**NESHAPS SUBPART DDDDD  
HEALTH-BASED COMPLIANCE  
ALTERNATIVE DEMONSTRATION**

***BUCKEYE FLORIDA, LIMITED PARTNERSHIP  
FOLEY MILL  
TAYLOR COUNTY, FLORIDA***

**RE: BUCKEYE FLORIDA, LIMITED PARTNERSHIP  
FACILITY ID: 1230001  
HBCA TITLE V PERMIT REVISION APPLICATION  
REQUEST FOR ADDITIONAL INFORMATION**

**FIGURE A**

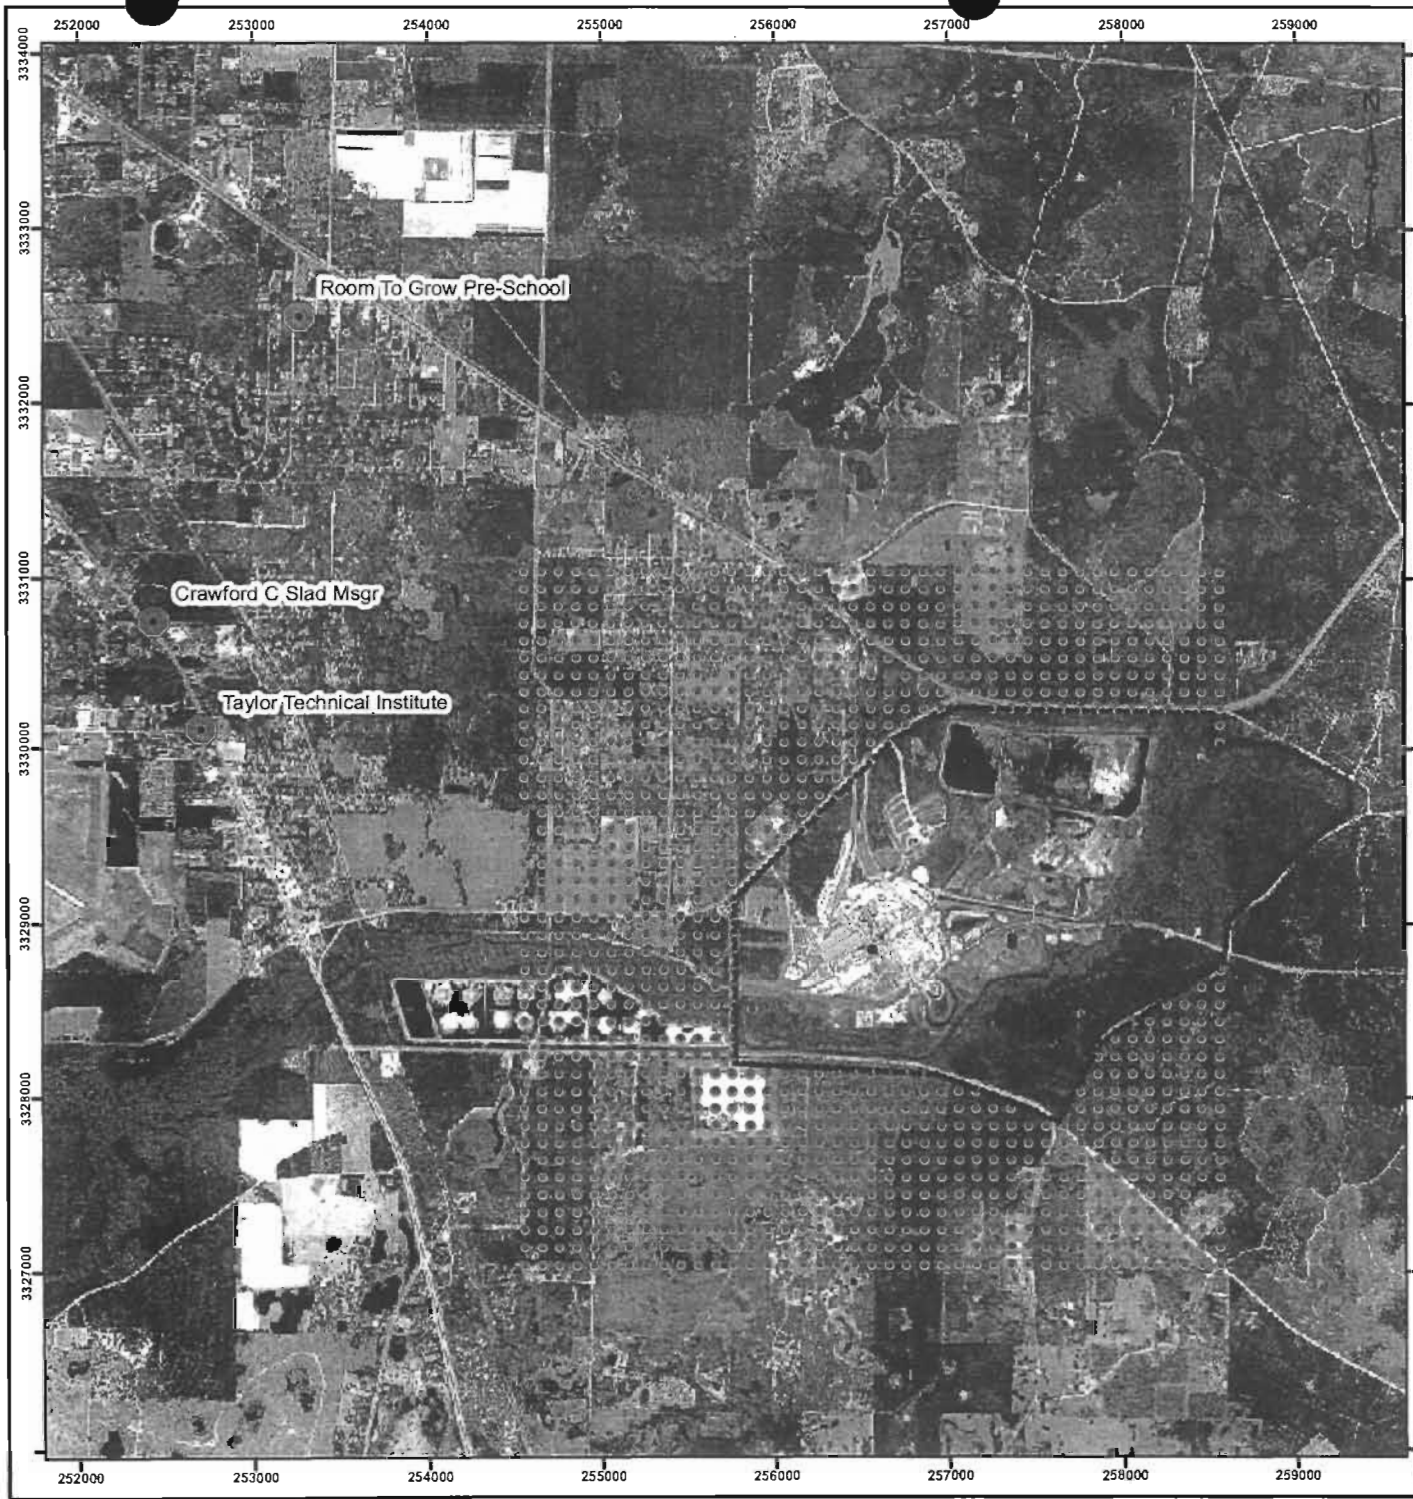
**Comment 2. In Figure 4-2 Receptor Grid Locations, please indicate what are the sensitive receptors (for example, school, daycare, senior community, hospital).**

**Response:** The area covered by the receptor grid in Figure 4-2, Receptor Grid Locations, does not contain any sensitive areas such as schools, daycares, hospitals, or senior communities. An additional figure, Figure A, Receptor Grid Locations and Sensitive Areas, has been developed to show the proximity of the receptor grid locations to any sensitive areas. The nearest sensitive area is Taylor Technical Institute, which is 1,850 meters west of the nearest receptor. Figure A is included with this response.
